Addendum No. 1  
RFP 15-102

### PUBLIC SAFETY COMPLEX CHILLER REPLACEMENT

10. **Item 8** – Complete all necessary Piping connections.

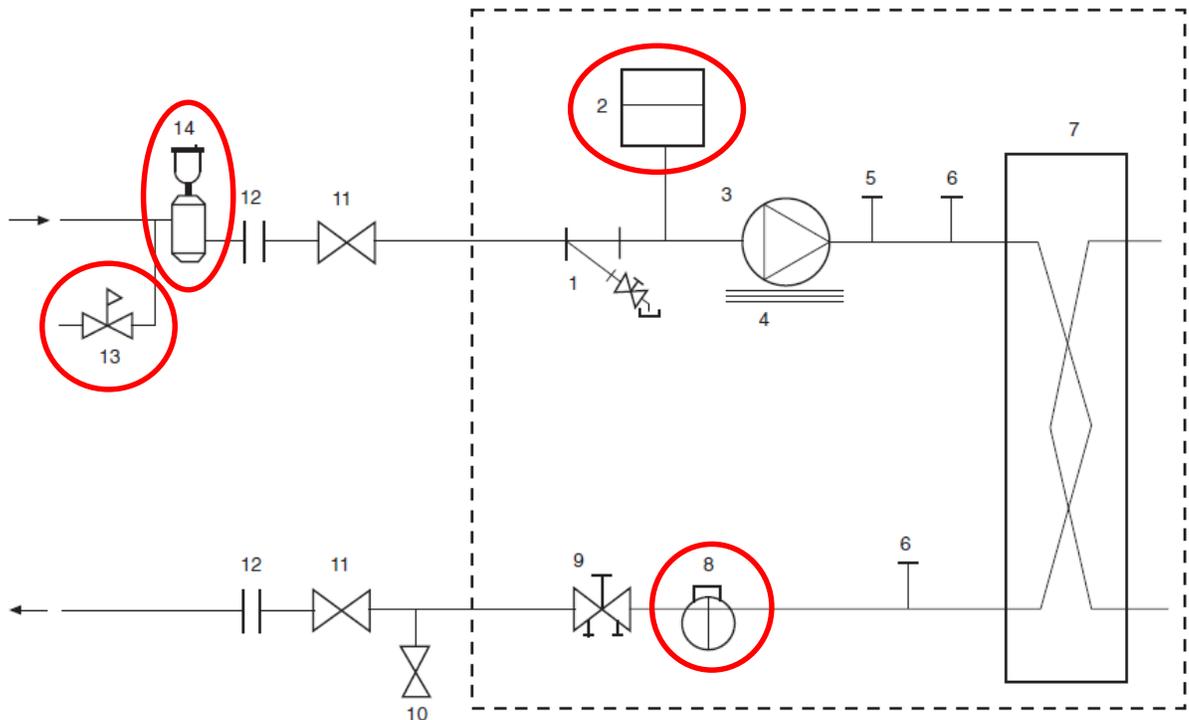
We were not shown the fill-station/pressure reducing and back-flow prevention devices which are necessary for both function and cross contamination protection of the city water supply (item 13 on diagram below).

a) Is a functional fill station and pressure reducing/back flow prevention station present?

b) Is an expansion tank present in the current piping design? (Item 2 below, shown within the chiller as part of the on-board pumping option).

*A: YES THIS IS STILL FUNCTIONAL AND WILL REMAIN.*

*A: YES AND THIS WILL BE REUSED.*
